ARCHITECTURAL REVIEW BOARD
CITY OF FREDERICKSBURG, VIRGINIA
AGENDA
January 13, 2020
7:00 P.M.
COUNCIL CHAMBERS, CITY HALL

TO: ARCHITECTURAL REVIEW BOARD
FROM: Kate Schwartz, Historic Resources Planner
DATE: January 8, 2020 (for the January 13, 2020 hearing)
SUBJECT: Certificate of Appropriateness for exterior alteration at 1311 Caroline Street

TO: ARCHITECTURAL REVIEW BOARD
FROM: Kate Schwartz, Historic Resources Planner
DATE: January 8, 2020 (for the January 13, 2020 hearing)
SUBJECT: Certificate of Appropriateness for accessory structure at 1114-1118 Caroline Street

1309 Carve
with two steps
← To Foundation
Carve step
into Rock 311

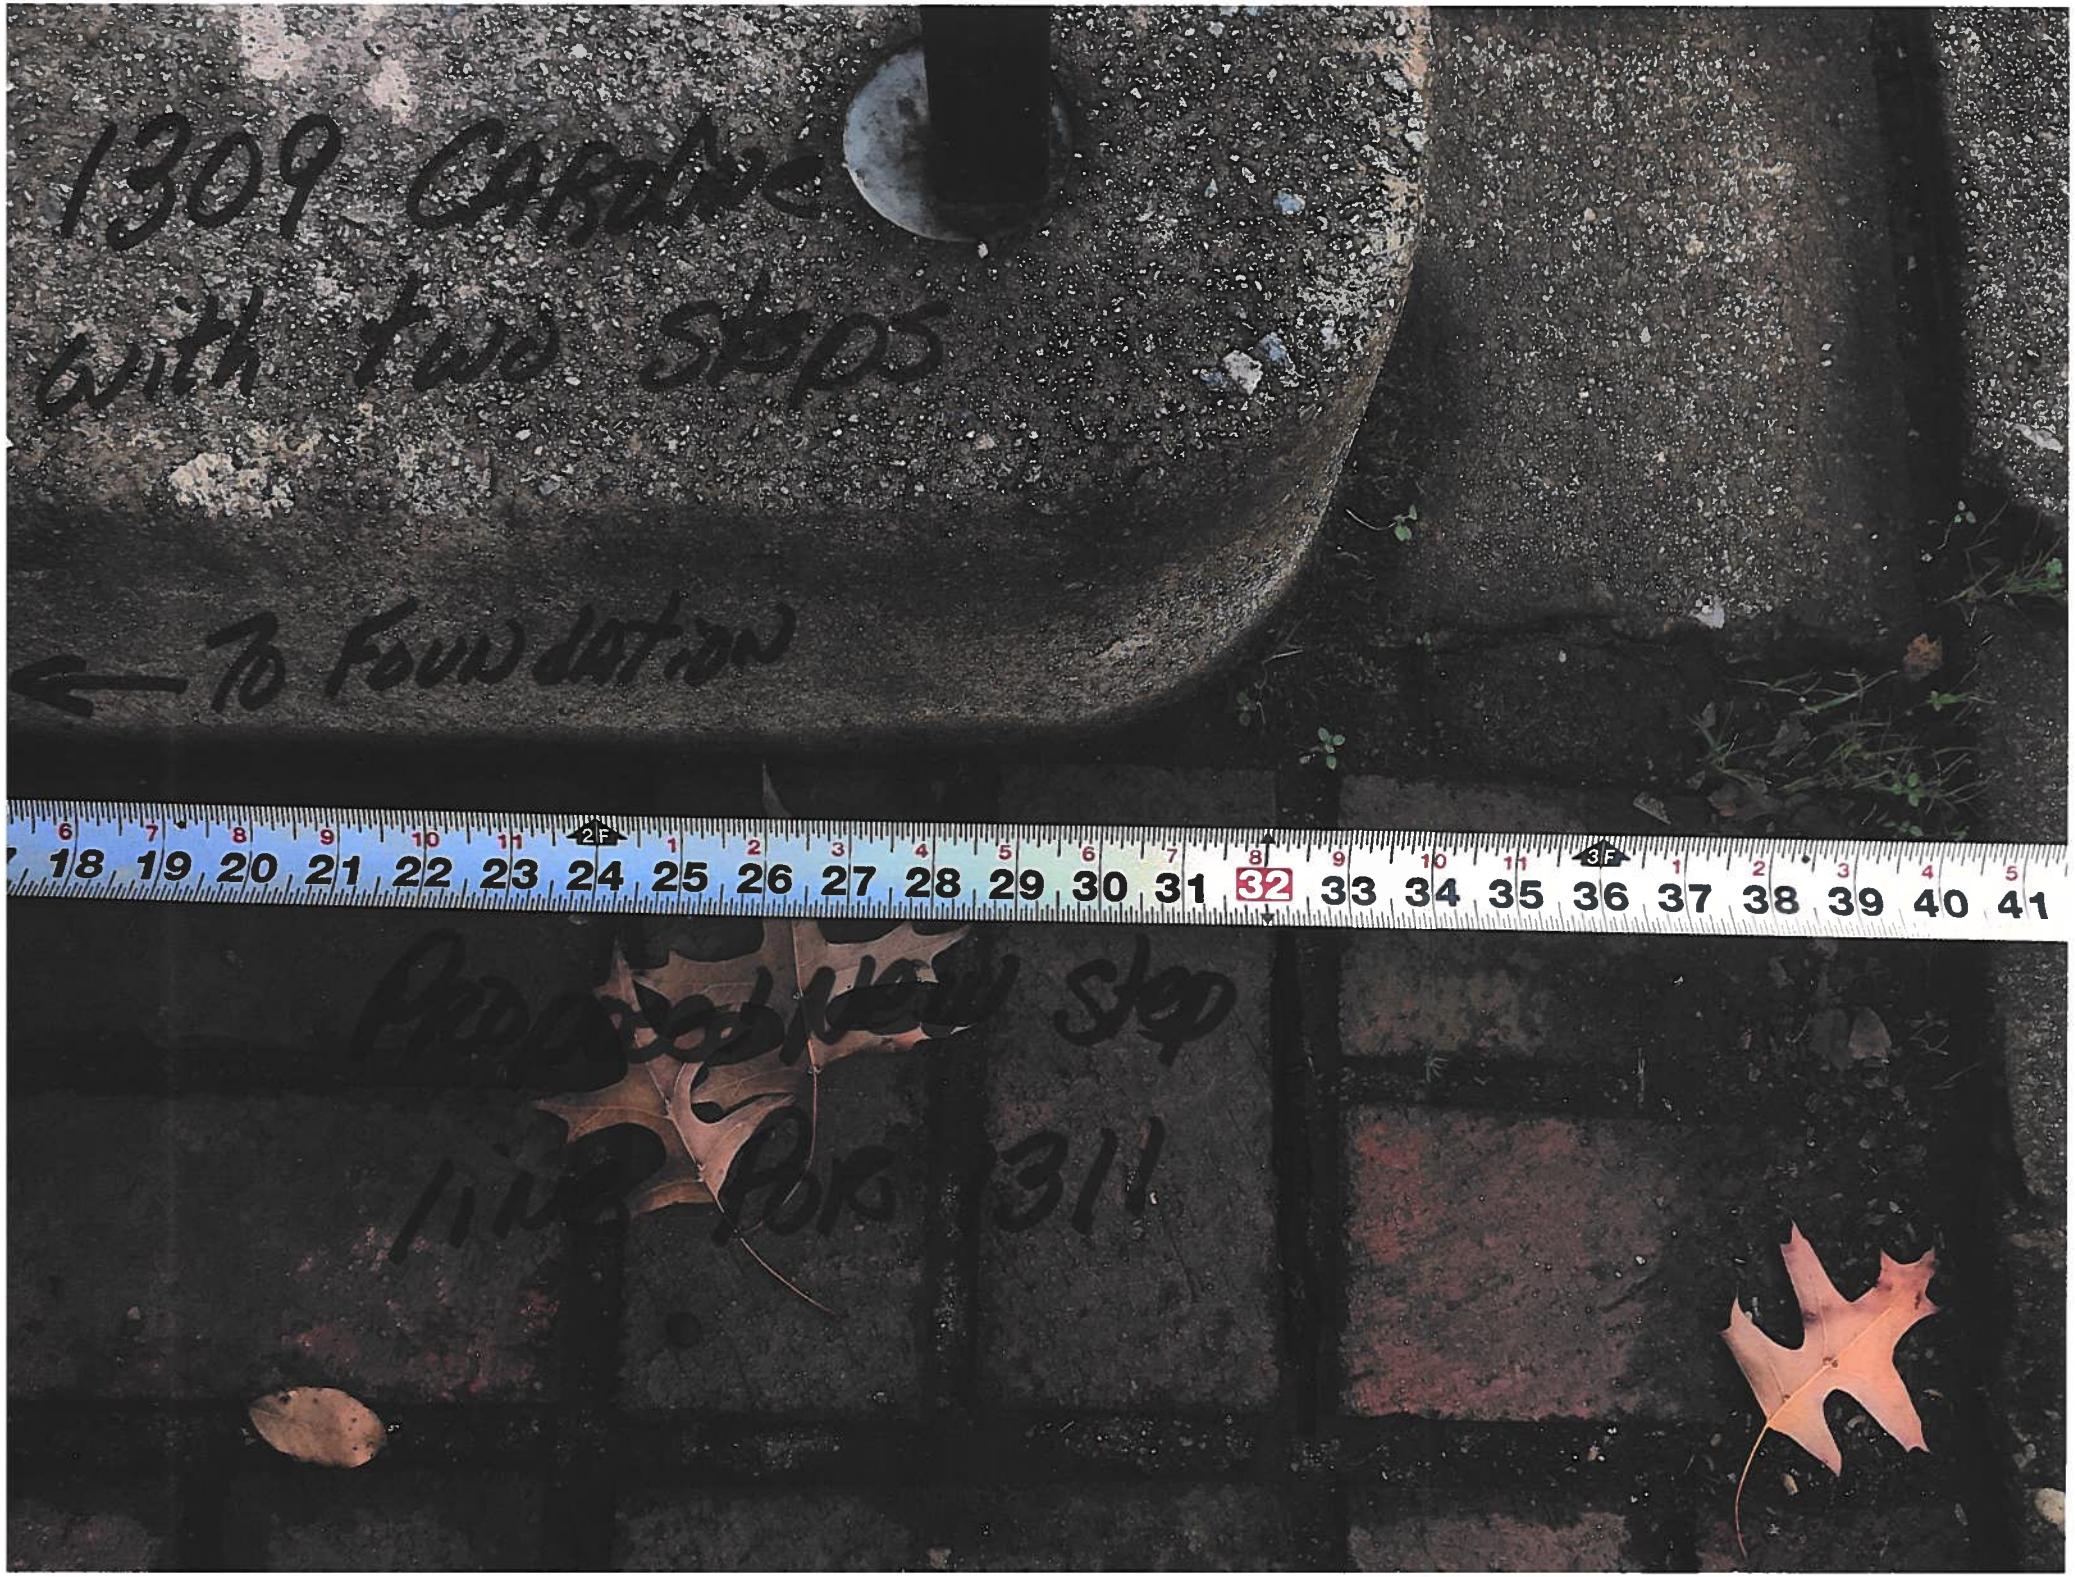
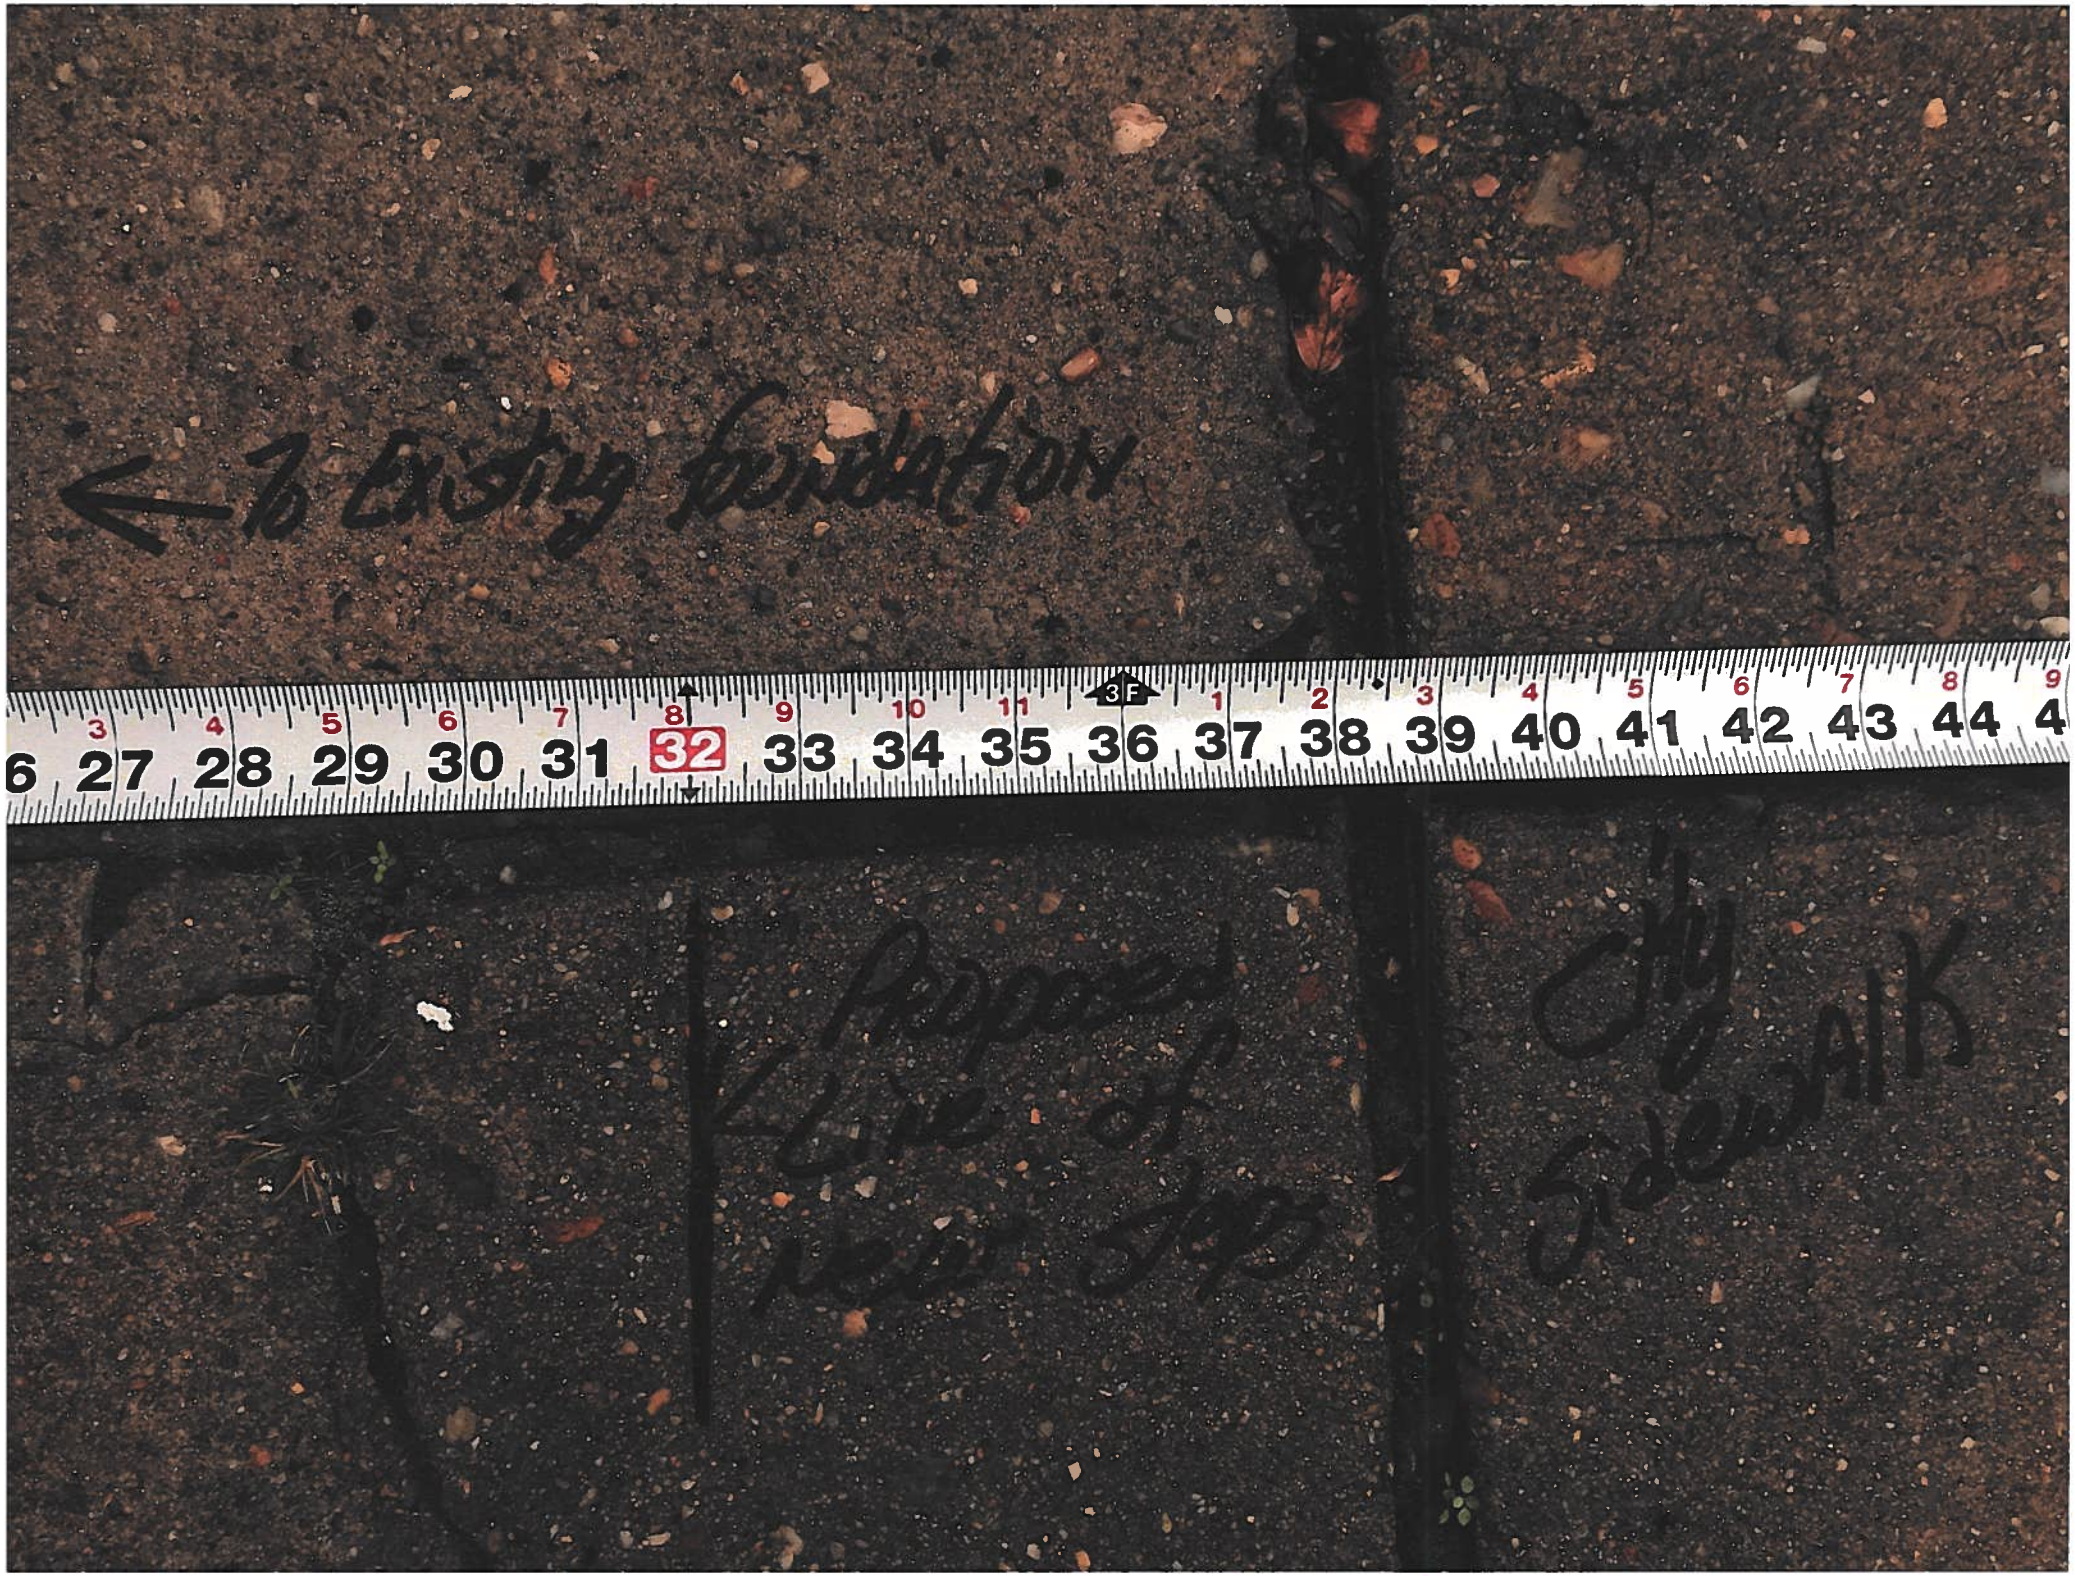
The applicant proposes to replace the single sandstone entry step that leads to the front door. The existing step is 8 ½ inches in height, with a 9 ½-inch elevation from the step into the house. The sandstone displays deterioration in the form of delamination, cracking, and erosion. For ease of access and safety, and due to the condition, the applicant proposes to remove the step and install two sandstone steps in its place. Two steps allow for an even six-inch rise at each step and into the house. The replacement material is variegated Tennessee sandstone, sawn and sand-blasted for a smooth finish.

The proposed replacement material closely matches the historic material and is appropriate for use. This alteration does not impact any character-defining features of the residence and will not affect its historic significance. Approval of the request as submitted is recommended.

Approval of the request for a Certificate of Appropriateness as submitted.
